ADDENDUM NUMBER 02 (REVISED)

DATE: January 23, 2024

PROJECT: Cass District Library Edwardsburg, MI

PROJECT NUMBER: 22-1836

**A2.2**

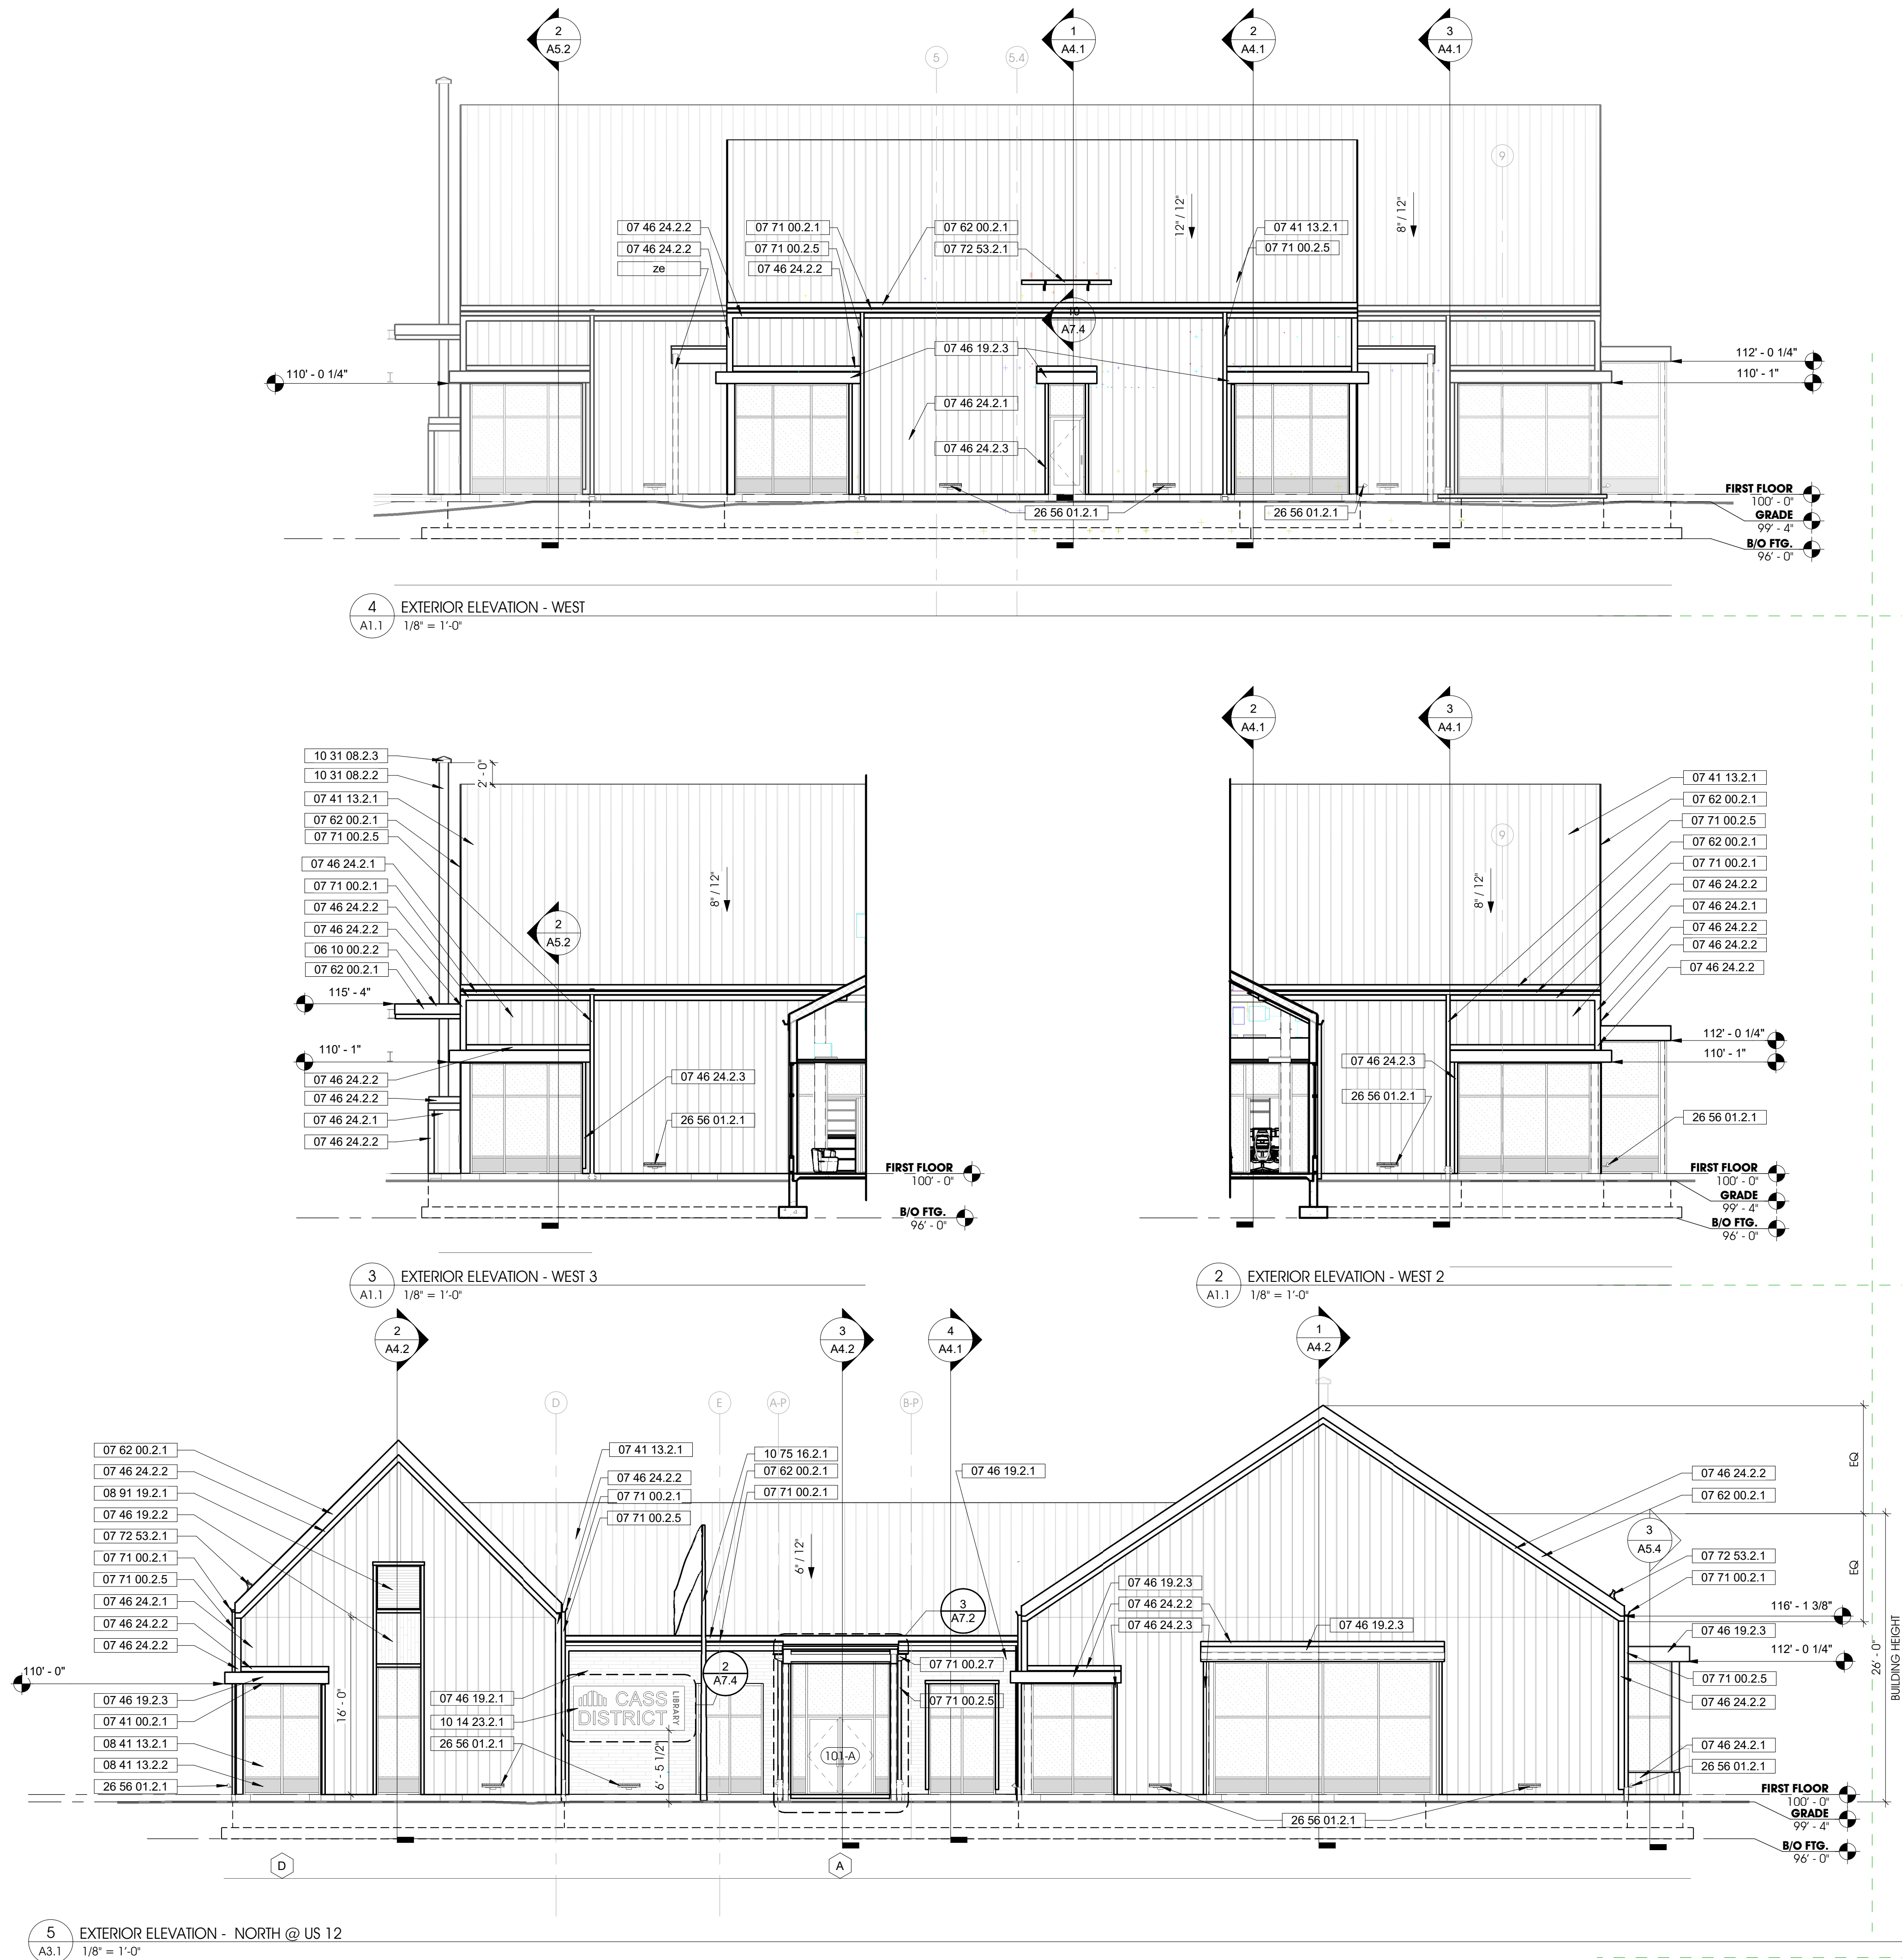
DRAWING A2.2 – ROOF PLAN (Re-Issued)

- 41. CLARIFY** Keynoting for Pac Clad Metal Roofing to Be Snap Clad System

**A3.1**

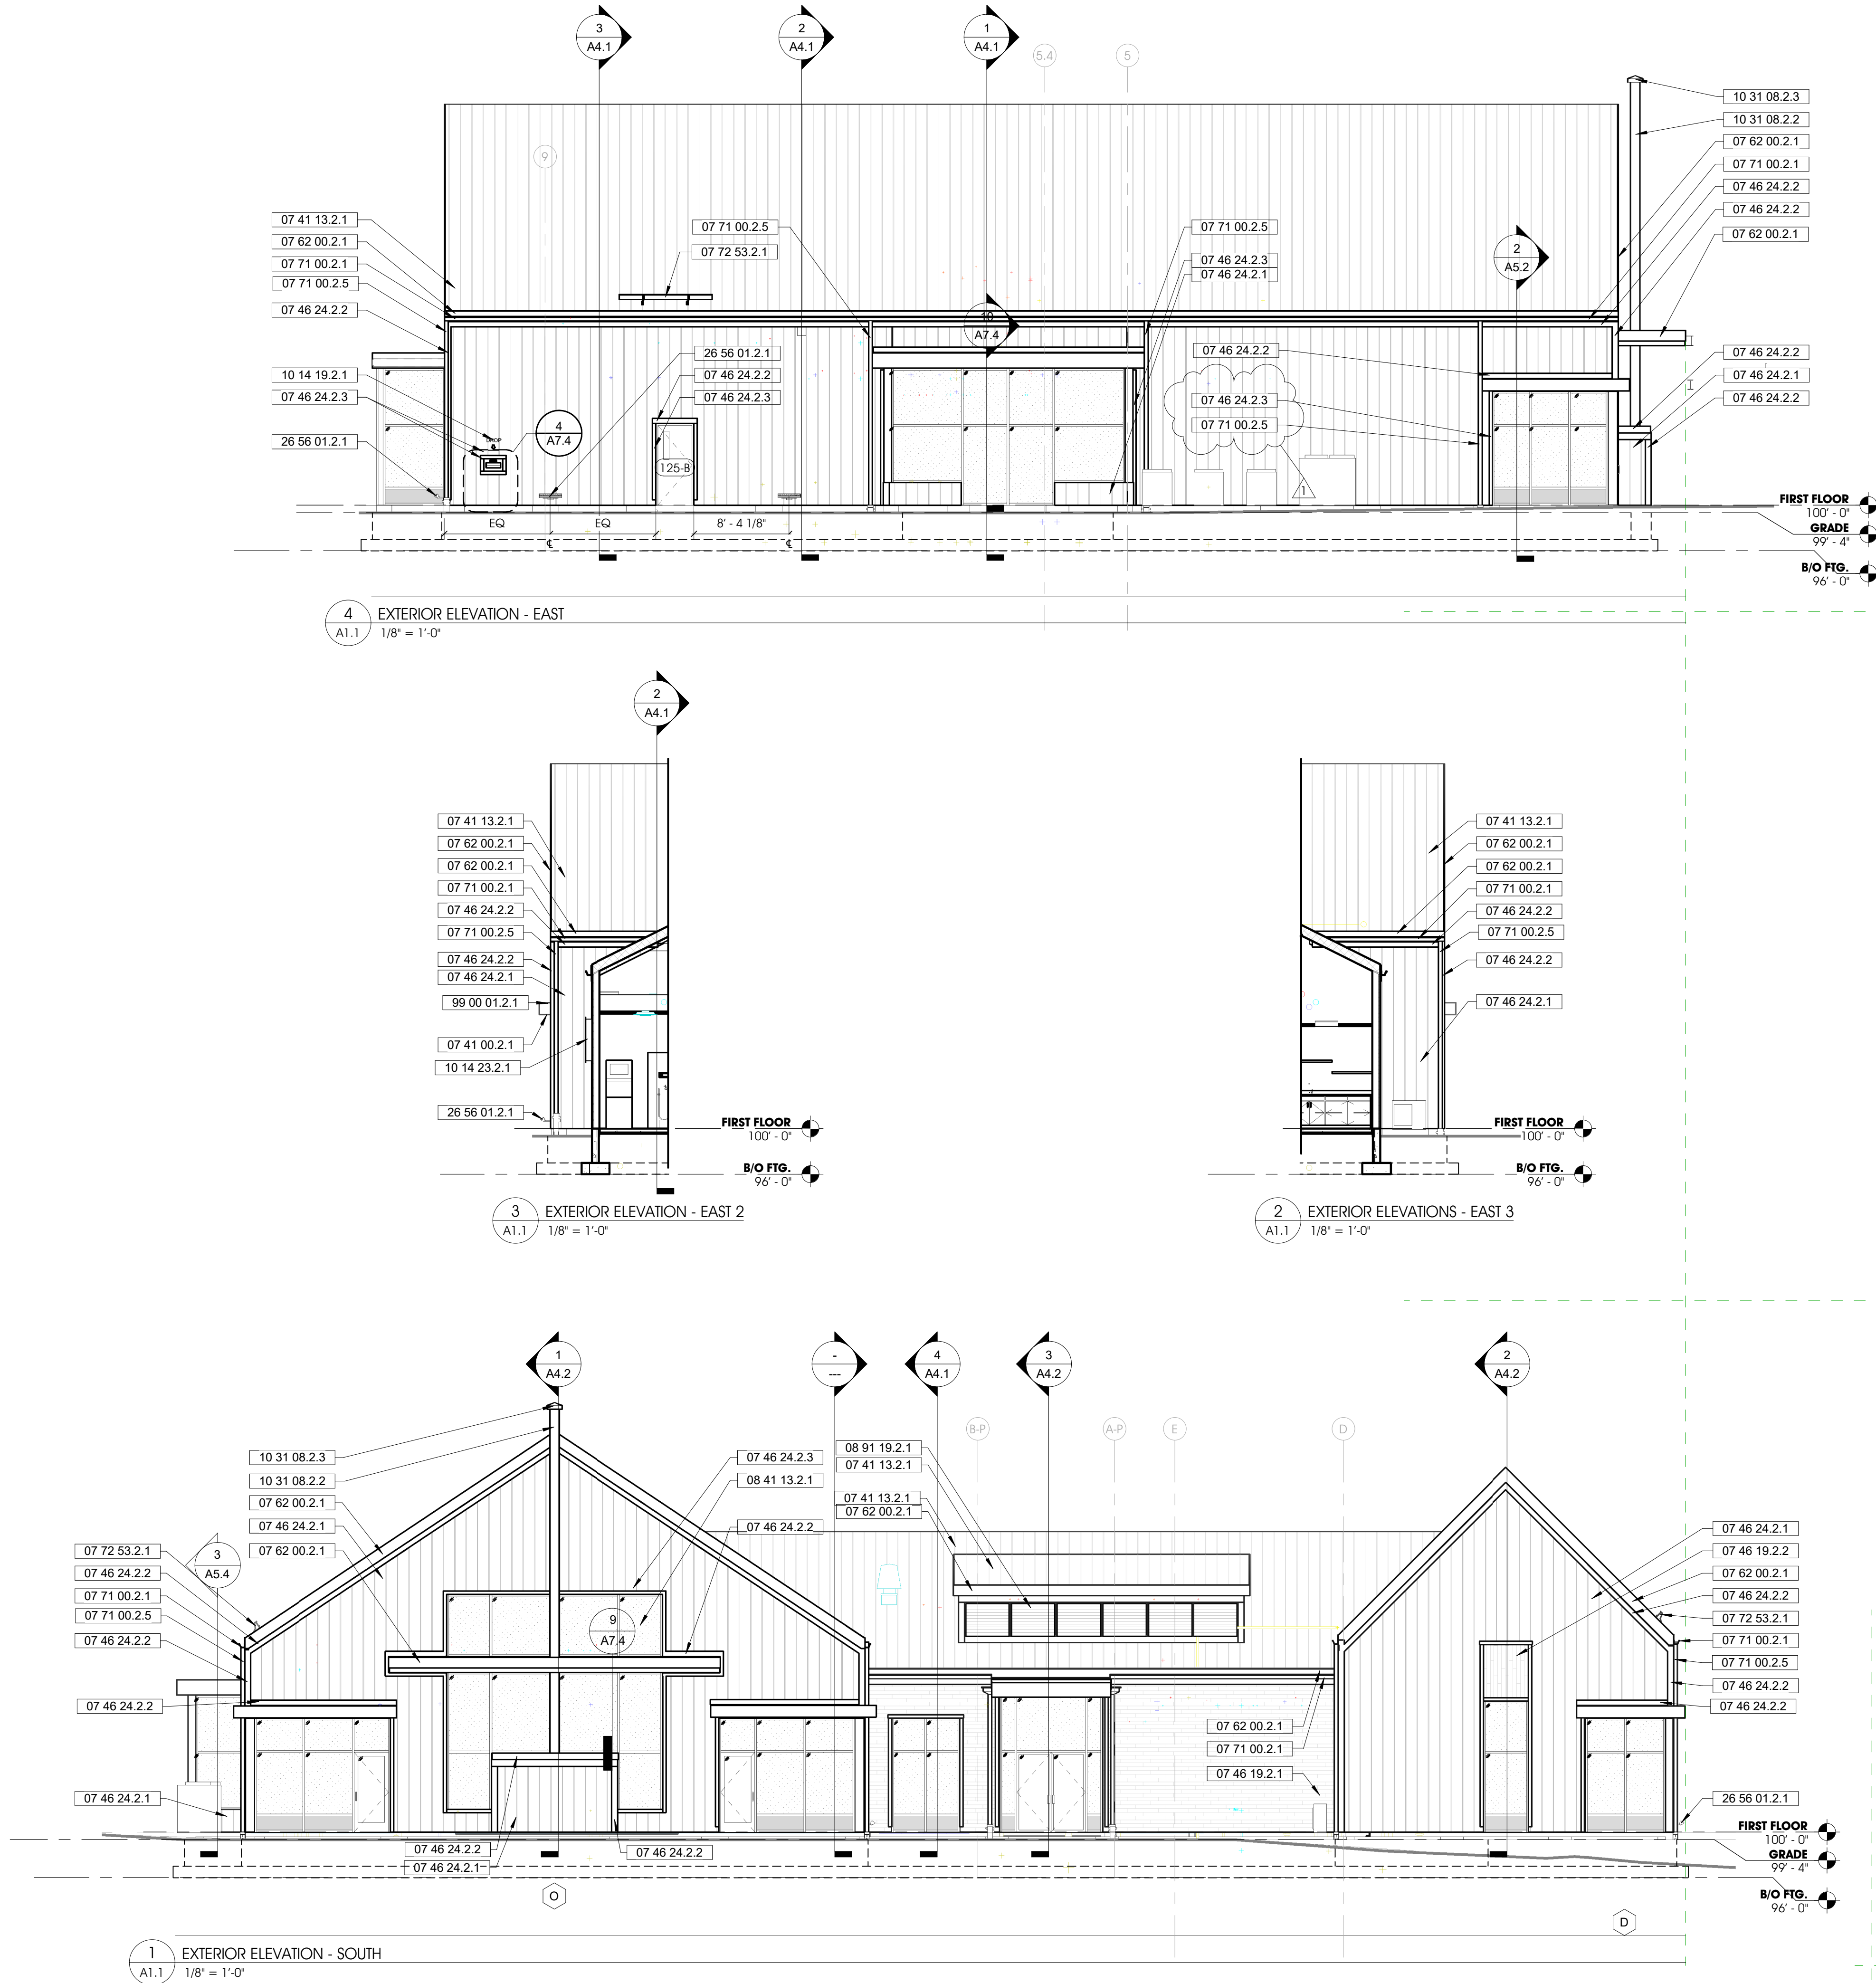
DRAWING A3.1 – EXTERIOR ELEVATIONS (Re-Issued)

- 42. REVISE** Exterior Elevations due to electronic printing errors.
